Re: Project Update and Response to WDNR Comments/Questions Regarding the Remedial Progress Report and Groundwater Treatment Plan One Hour Martinizing 285 E. Hampton Ave Milwaukee, Wisconsin 53217 BRRTS#: 02-41-543260 FID#: 241176650

EnviroForensics, LLC (EnviroForensics) has reviewed your comments and questions presented in your October 1, 2018 letter regarding our submittal of the Remedial Progress Report and Groundwater Treatment Plan for the One Hour Martinizing site located at 285 E. Hampton Avenue in Milwaukee, Wisconsin.

Figure	1
Project	6194

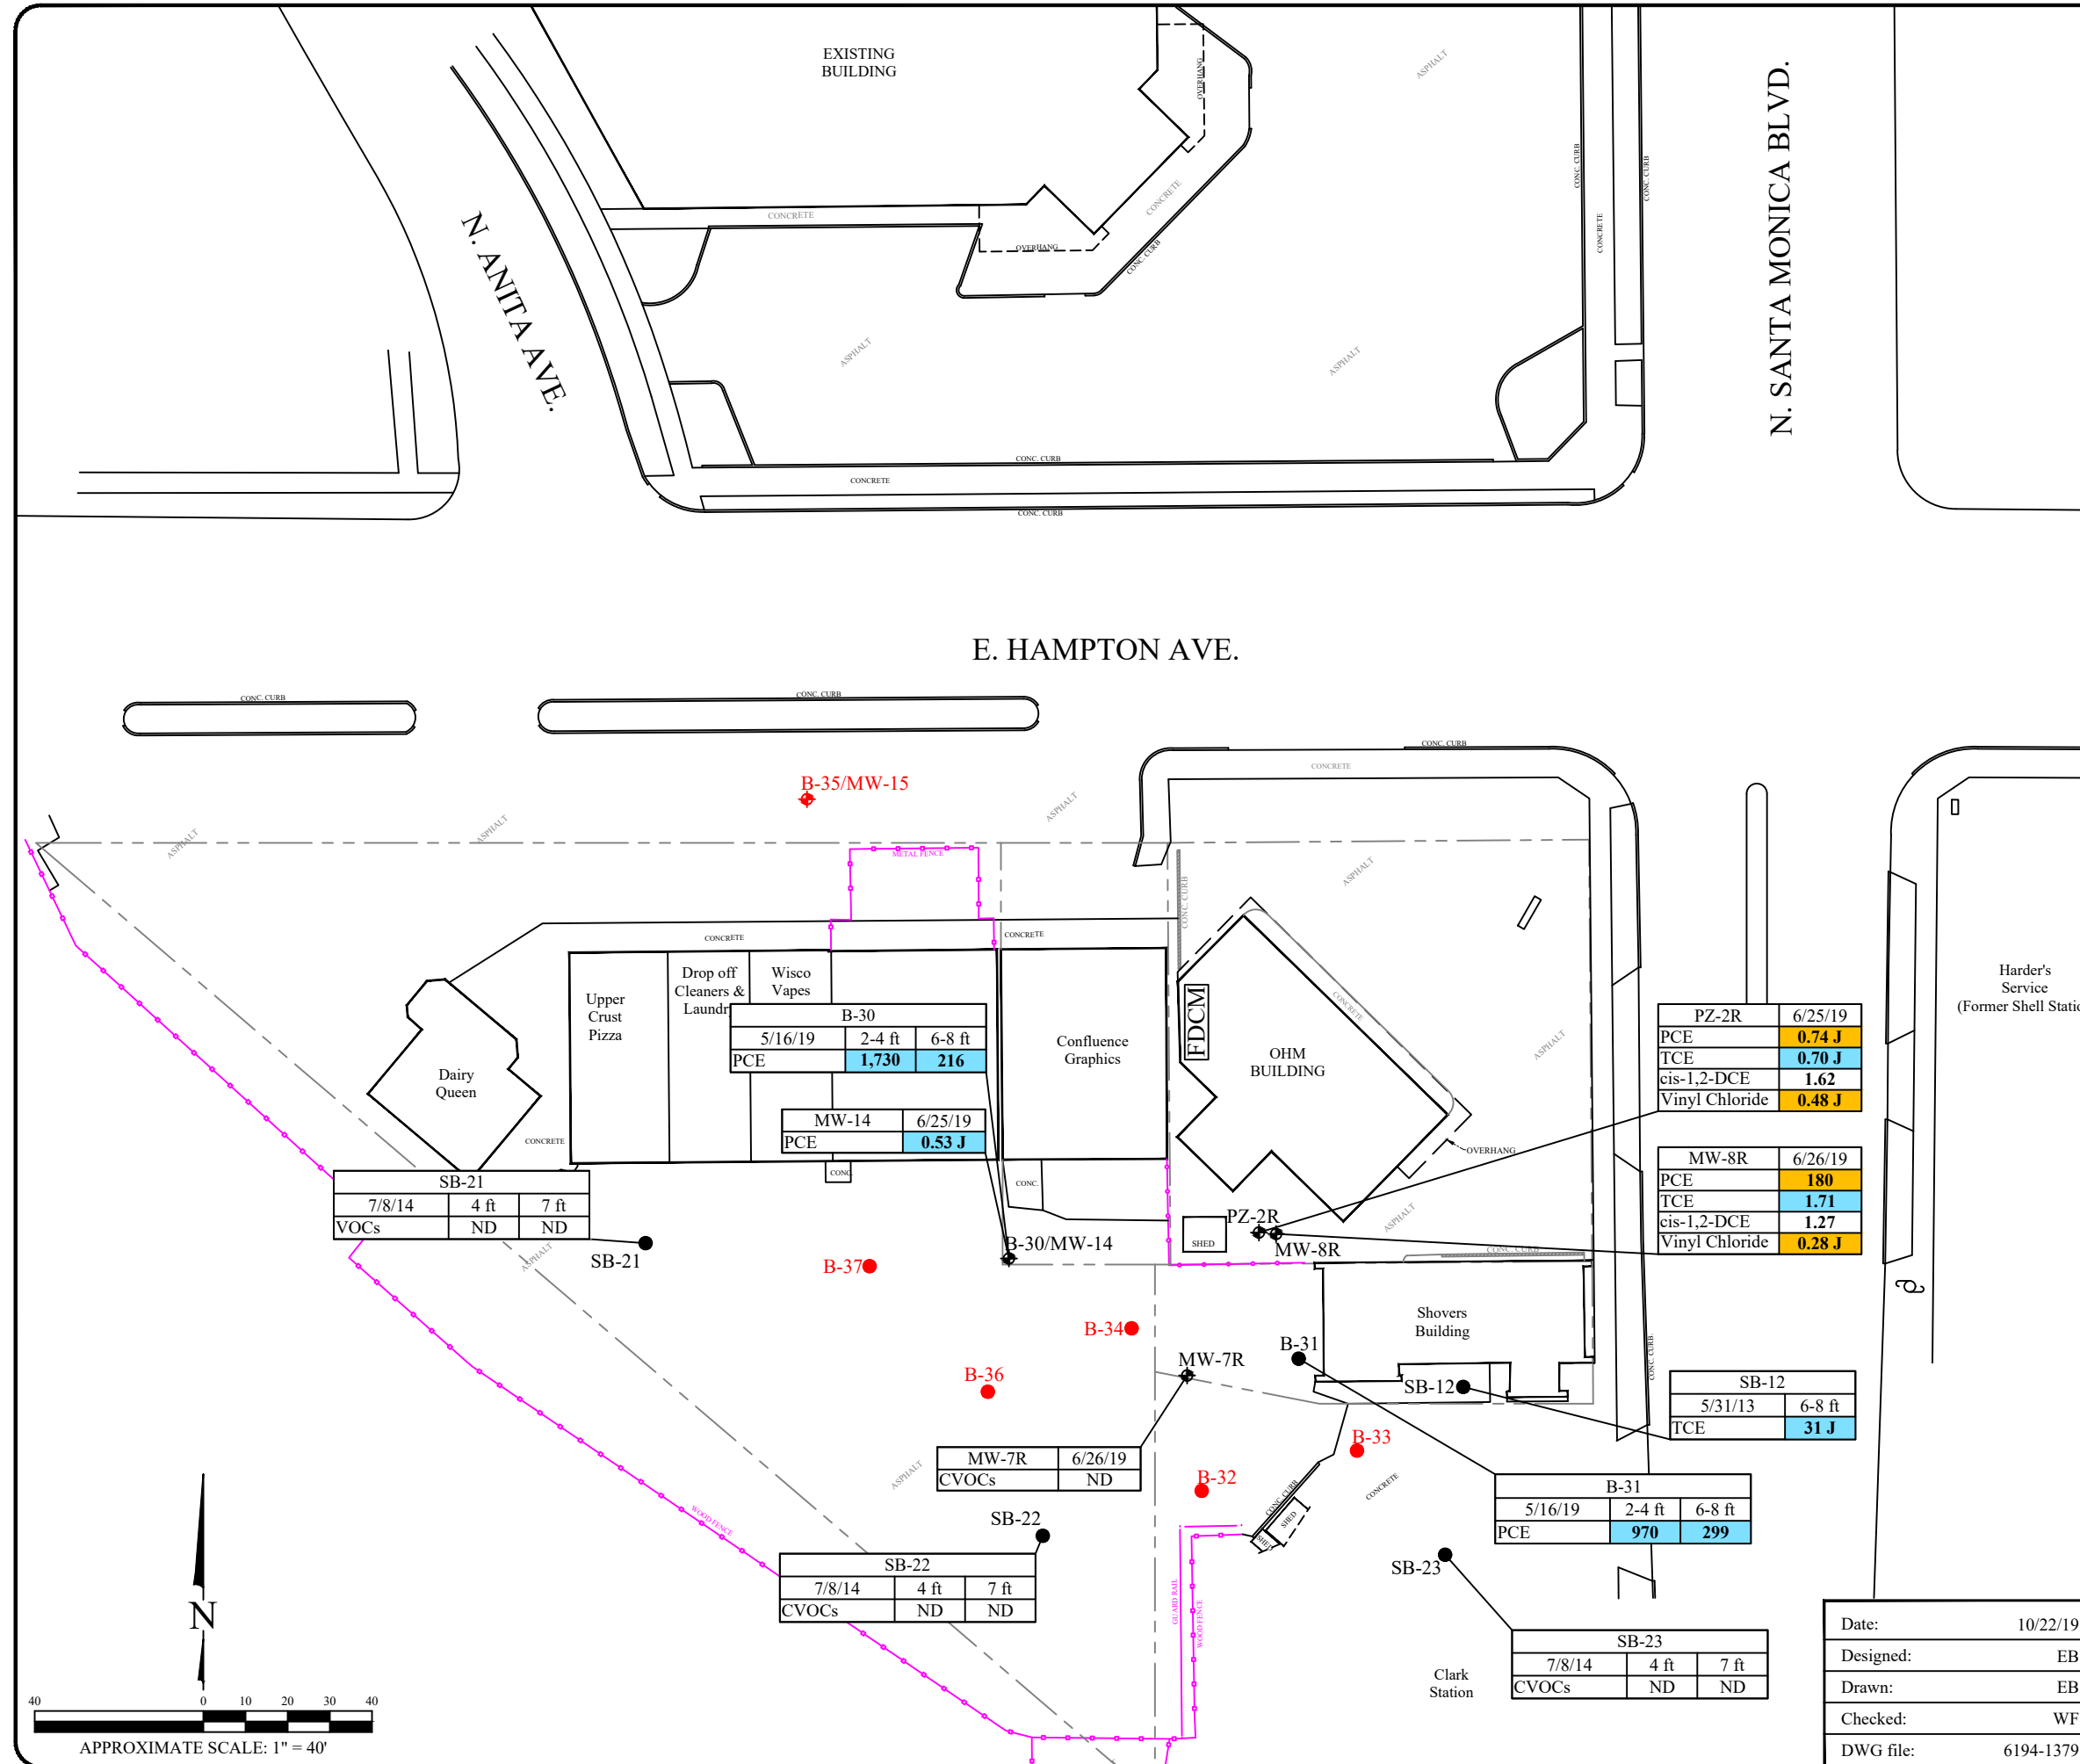
Question #3: Removal of the PCE source in the southern area was part of the remedial action for the site. Enviroforensics has proposed to treat groundwater through injection of an enhanced reductive dichlorination product to reduce the concentrations in the groundwater plume. Because groundwater samples have not been collected since the soil source removal, the DNR suggests that you consider reinstalling groundwater monitoring wells MW-7R, MW-8R, and PZ-2R and sample all wells to determine what effect the excavation has on groundwater quality before you proceed with the proposed injection. Quarterly groundwater monitoring as proposed may indicate that natural attenuation alone is sufficiently remediating the groundwater. The DNR also recommends installation of additional groundwater monitoring wells near the former SB-17/GW-1 location and west of the shed near the former SB-27/GW-7 location to bound the degree and extent of the groundwater plume (see Figure 10).

We have proceeded with the installation of monitoring wells MW-7R, MW-8R, and piezometer PZ-21R that we previously proposed and have installed MW-14 that you suggested for monitoring the plume edges. We have developed and sampled these wells one time, the results of which are provided on attached **Figure 1**. Historic results of groundwater sampling for the wells within and near the excavated area are presented in the attached **Table 1**. As can be seen in this table, the concentrations of chlorinated solvents in replacement wells MW-7R, MW-8R and nearby well MW-2 have diminished significantly. We intend to sample the wells up to another seven consecutive quarters to determine plume stability and the likelihood that natural attenuation mechanisms will eventually abate the chlorinated solvent impacts.

We currently have completed soil borings B-30 and B-31 shown on **Figure 1**, and the analytical results from these borings are shown on this figure. We have gained access for sampling at B-32 and B-33, and

Answer: We will investigate the remaining groundwater impacts within the center and around the perimeter of the groundwater plume following the partial excavation of contaminated soil as you have requested. To accomplish this, we have installed wells MW-7R, MW-8R, MW-14, and PZ-2R at the locations shown on attached **Figure 1**. Upon resolving access issues, MW-15 will be installed on the Hampton WFB, LLC property.

GEOLOGIC CROSS SECTION A-A'

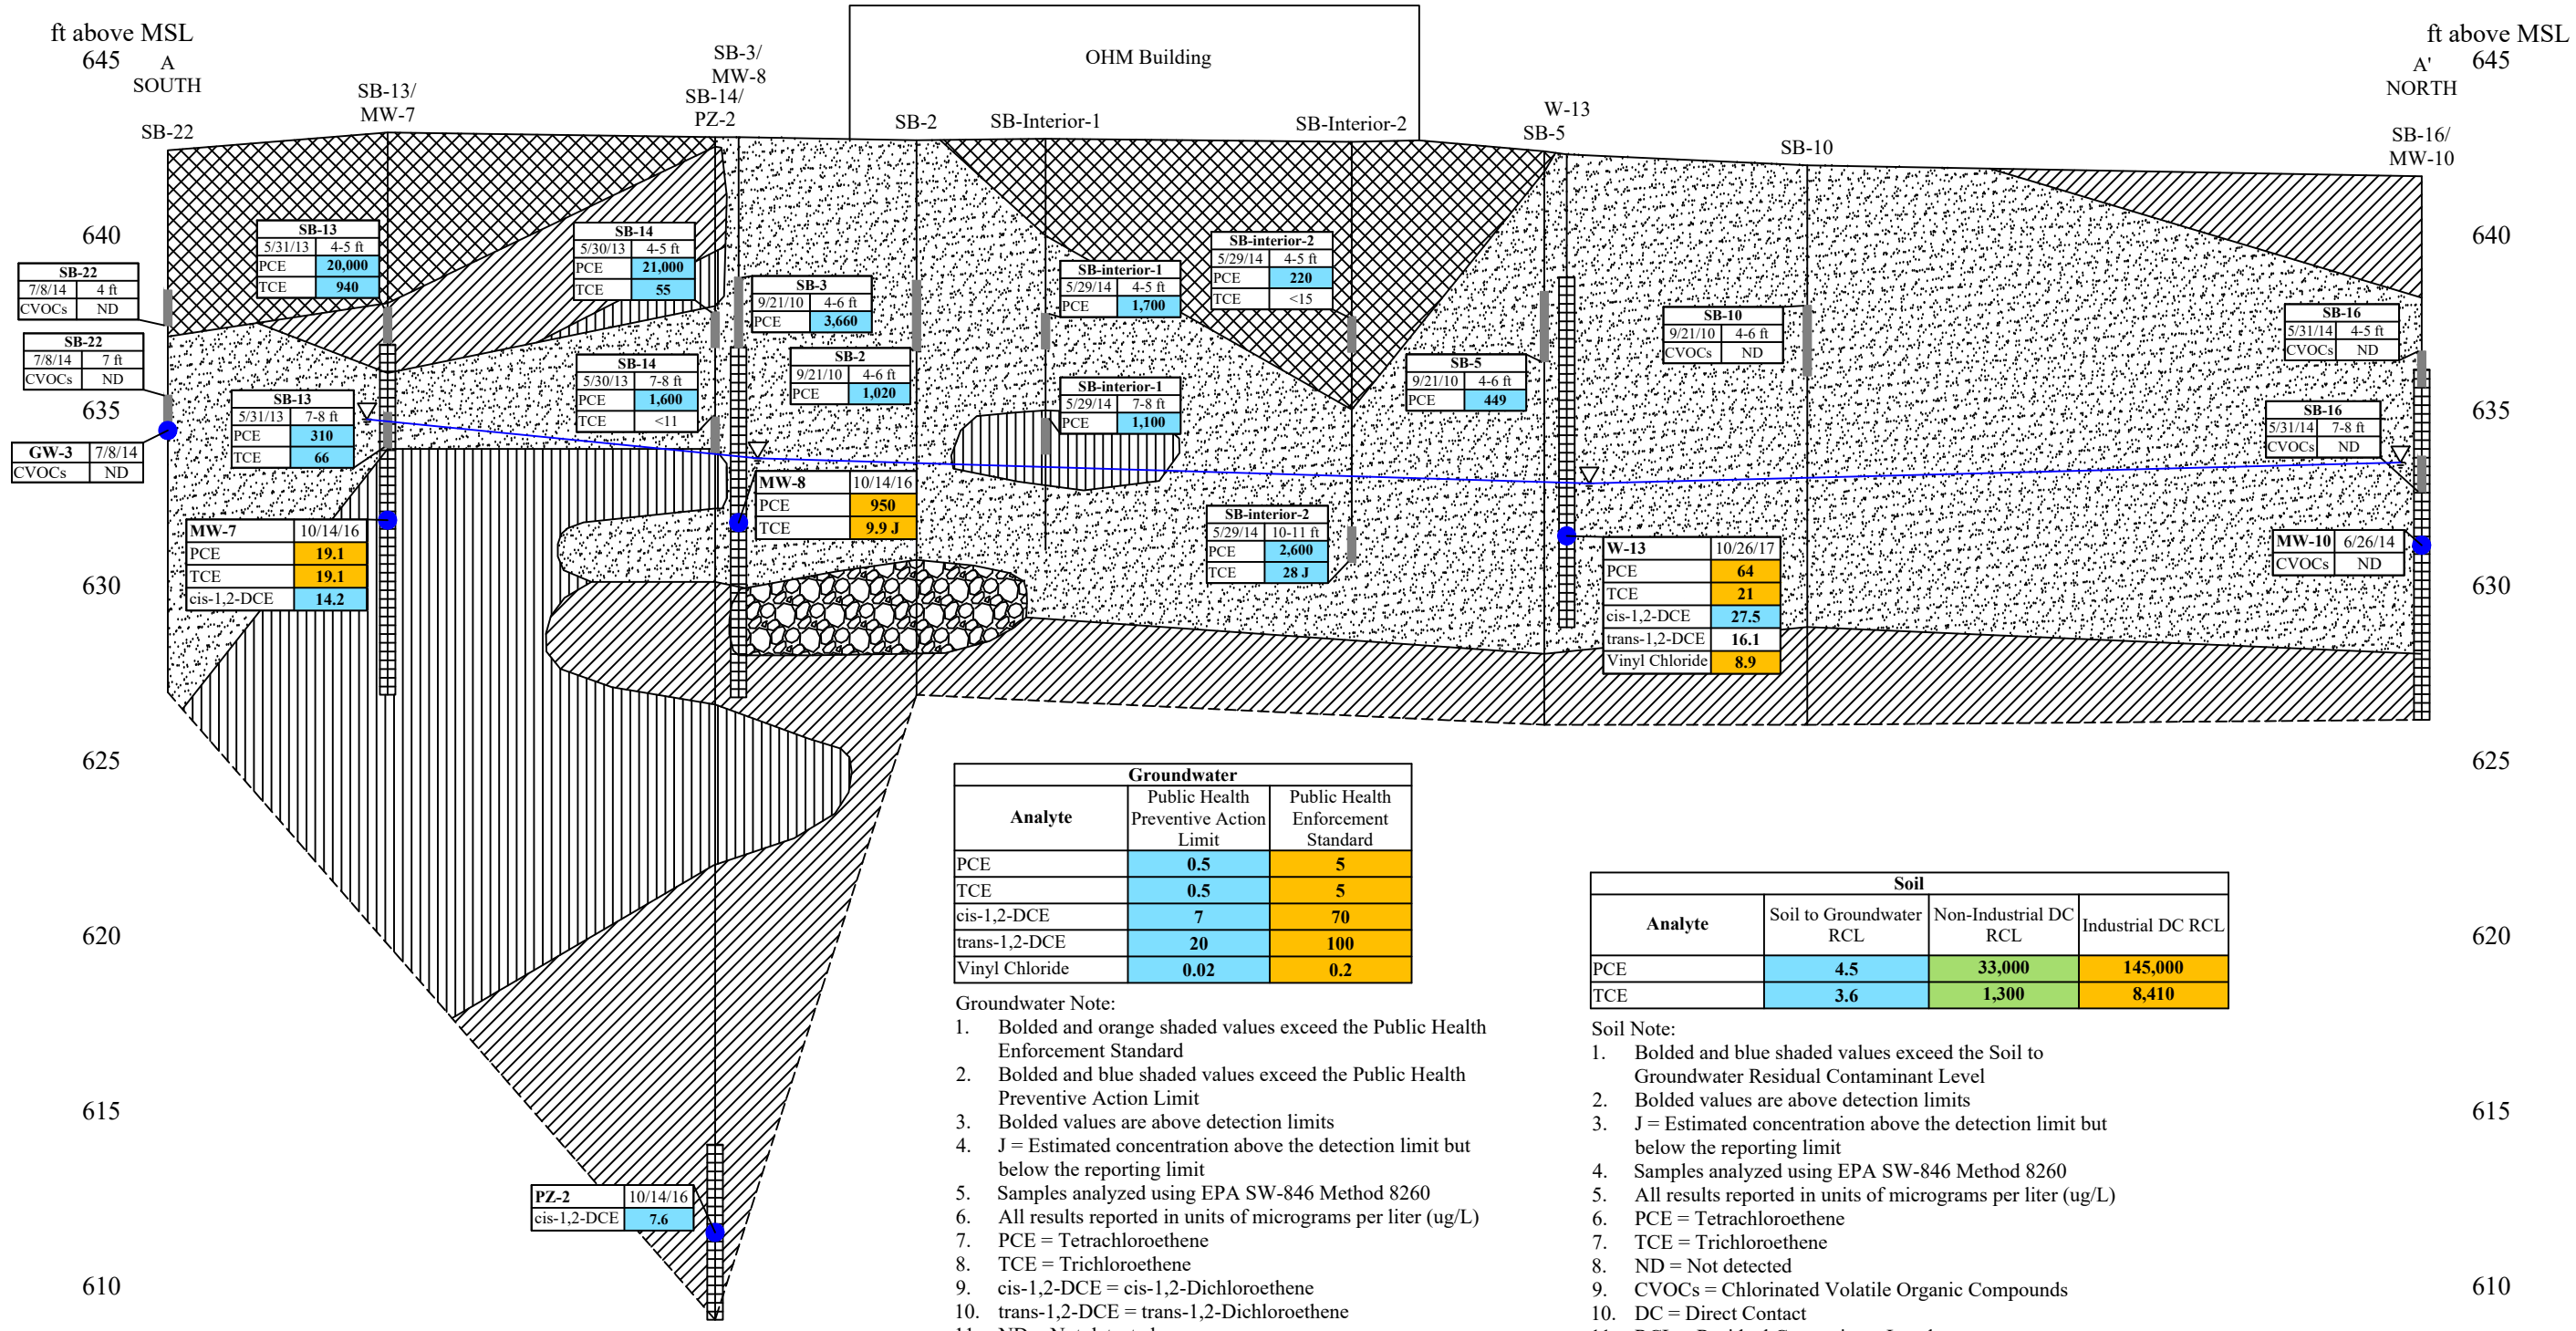
The attached Figures 3, 4, 8, and 9 have been revised as you requested.
